SERVICE LETTER

No. 783

Piper Aircraft Corporation

Subject: Inspection of Air Conditioning System
Capillary Sensor

VIEW LOOKING AFT AT EVAPORATOR UNIT

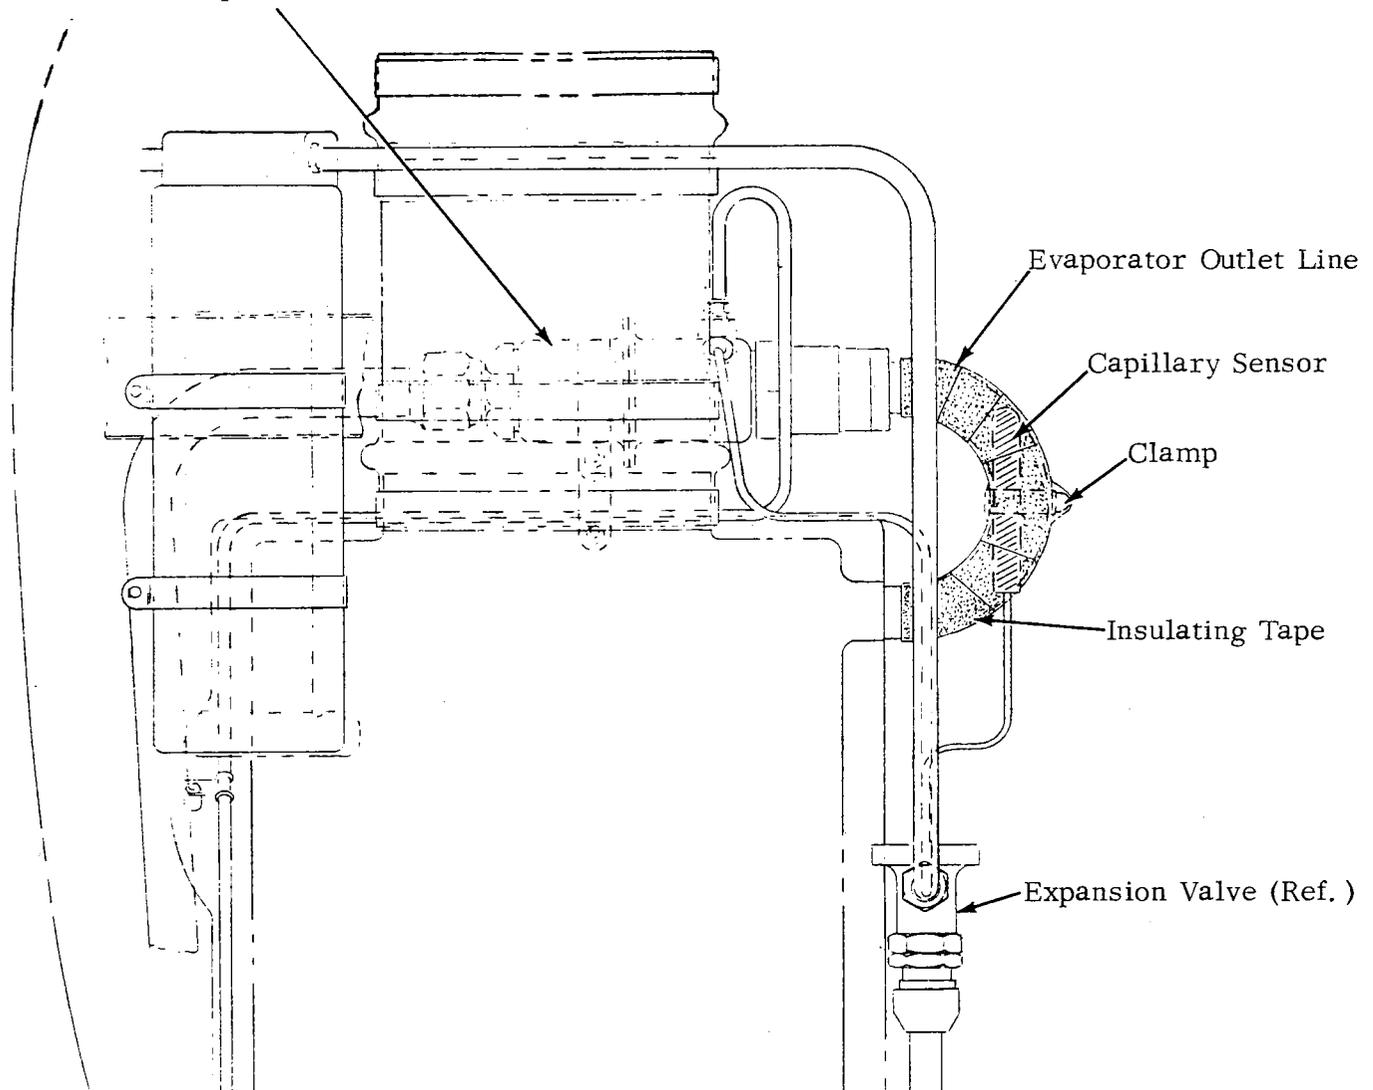
The capillary sensor is a self contained sensing device mounted against the air conditioning system evaporator outlet (from the evaporator to the evaporator control valve) line, to detect the temperature of the system refrigerant. It has been brought to our attention that the capillary sensor may not be securely mounted in its proper position (i.e., under the insulation) on the evaporator outlet line. This condition could cause improper refrigerant temperature readings, with possible system refrigerant exhaustion and/or freon compressor oil starvation.

1. Remove access panels from both sides of fuselage nose section to gain access to the evaporator unit.
2. Inspect capillary sensor to determine if it is properly positioned and clamped against the evaporator outlet line as shown above.

- a. If clamp is present and capillary sensor does not protrude above the curvature of the evaporator outlet line, no further action is required.
 - b. If clamp is not present and/or if capillary sensor protrudes above the curvature of the evaporator outlet line, proceed as follows.

1. Carefully remove insulating tape from evaporator outlet line and capillary sensor. Clean tape residue from line and sensor using MEK or acetone.
 2. Secure sensor to line, as shown above, using clamp P/N 454 921 (SAE Type 10 or Breeze #QS100-M10).

3. Apply insulating tape P/N 189 777 (P. T. I. Prestite Insulating Tape 1/8" x 2") over outlet line, capillary sensor and clamp.
3. Reinstall access panels and make proper logbook entry of Service Letter 783 compliance.
